Subject: BAR Actions - June 21, 2016 - 111 W High Street

BAR 16-06-01
111 West High Street
Tax Parcel 330111000
Marianne and Gerry Starsia, Owner/Applicant
Exterior Renovations - Tree Removals, Window/Door Exchange, and Porch Renovations

CITY OF CHARLOTTESVILLE BOARD OF ARCHITECTURAL REVIEW STAFF REPORT June 21, 2016

Certificate of Appropriateness Application
BAR 16-06-01
111 West High Street
Tax Parcel 330111000
Marianne & Gerry Starsia, Owner/Applicant
Exterior Renovations - Tree Removals, Window/Door Exchange, and Porch Renovations

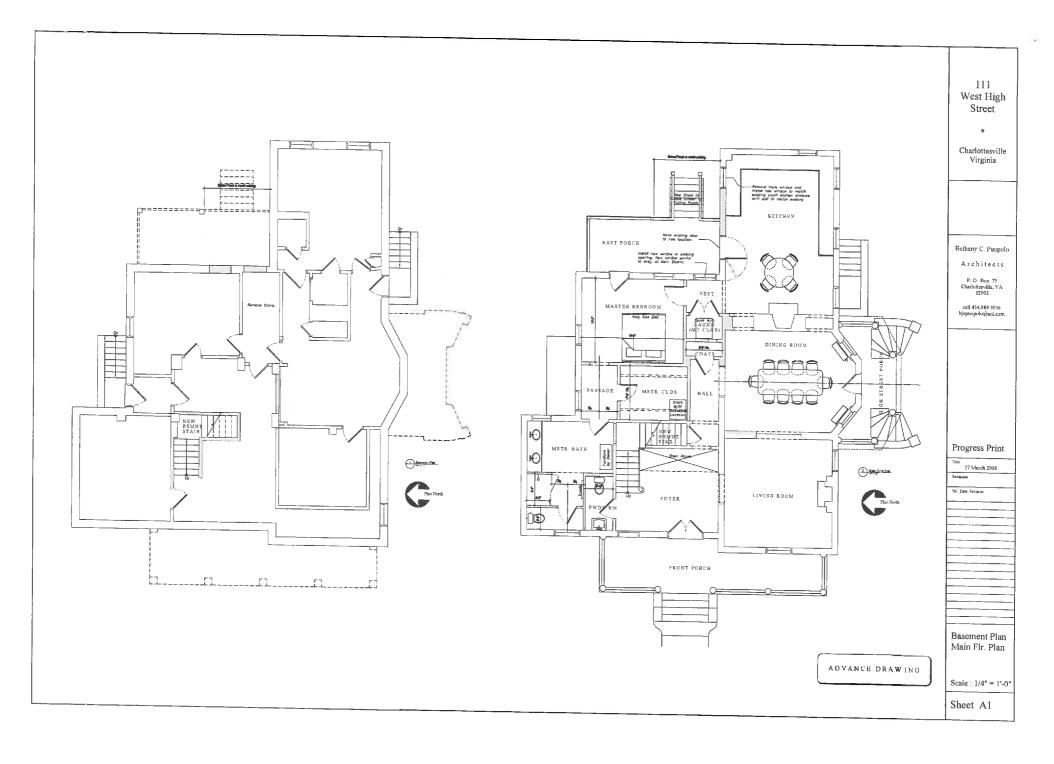
I would draw your attention to the infill and installation of the new window by the porch on Drawing D-1 by the kitchen. We want to extend the porch, incorporating all the existing details, to the room marked "Kitchen" and infill and install a new window to match the rest of the house. Bethany believes that the original house had the same double hung windows on both sides of that room so we are putting it back to original.
